PD Modification Application: MM 24-1141 (Remand)

Hillsborough
County Florida

Development Services Department

PETITION NO: MM 24-1141

8.2.1 Proposed Site Plan (Full)

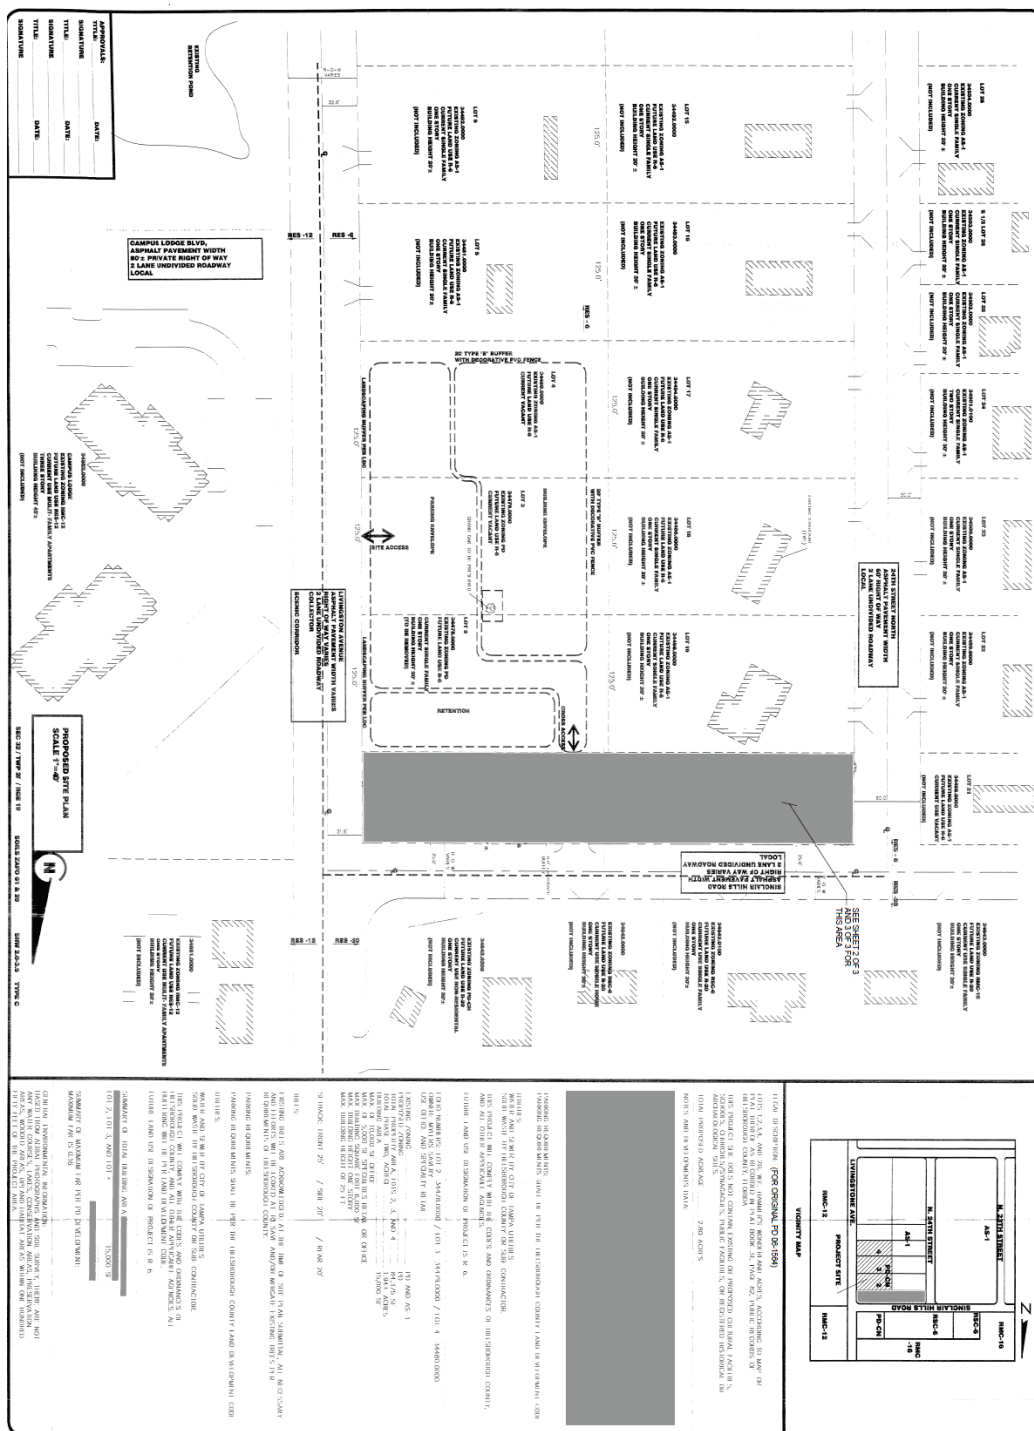
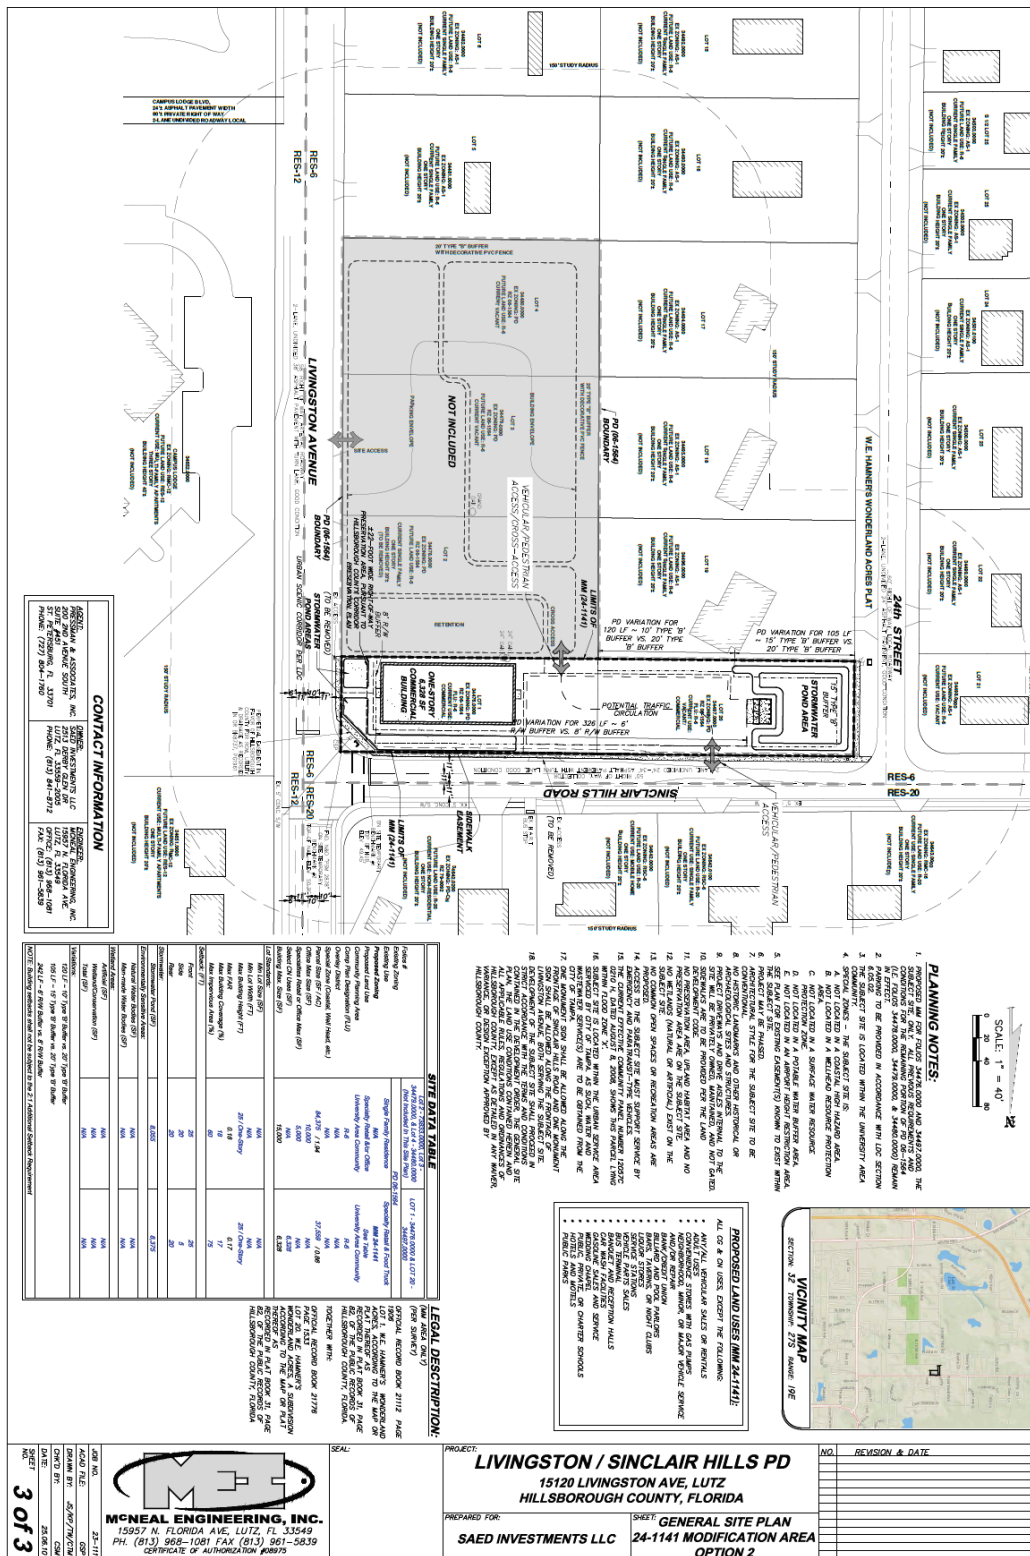
The applicant has requested six PD Variations to LDC Section 6.06.06., three for each option.

1. According to LDC Section 6.06.06, a 20-foot-wide buffer with Type B screening is required along the south property line where abutting the AS-1 zoned residential to the south. The applicant is requesting a variation from these requirements within proximity of the food truck to the south to allow a 5-foot-wide buffer with Type B screening that is 31 length feet.

2. According to LDC Section 6.06.06, a 20-foot-wide buffer with Type B screening is required along the south property line where abutting the AS-1 zoned residential to the south. The applicant is requesting a variation from these requirements for the remaining length of the property line to the south to allow a 15-foot-wide buffer with Type B screening that is 194 length feet.

3. According to LDC Section 6.06.06, an 8-foot-wide right of way buffer is required to the north property line towards Sinclair Hills Road. The applicant is requesting a variation from these requirements to allow a 6-foot-wide right of way buffer towards Sinclair Hills Road to the north that is 242 length feet.

4. According to LDC Section 6.06.06, a 20-foot-wide buffer with Type B screening is required along the south property line where abutting the AS-1 zoned residential to the south. The applicant is requesting a variation from these requirements to allow a 10-foot-wide buffer to the south with Type B screening that is 120 length feet.

5. According to LDC Section 6.06.06, a 20-foot-wide buffer with Type B screening is required along the south property line where abutting the AS-1 zoned residential to the south. The applicant is requesting a variation from these requirements to allow a 15-foot-wide buffer to the south with Type B screening that is 105 length feet.

6. According to LDC Section 6.06.06, an 8-foot-wide right of way buffer is required to the north property line towards Sinclair Hills Road. The applicant is requesting a variation from these requirements to allow a 6-foot-wide right of way buffer towards Sinclair Hills Road to the north that is 242 length feet.

Staff opposes these LDC Section 6.06.06 PD variation requests, as they would not provide sufficient buffering to protect residential areas from potential noise and disruptions caused by the commercial activities. However, Natural Resources does not object to the vehicular use area PD variations.
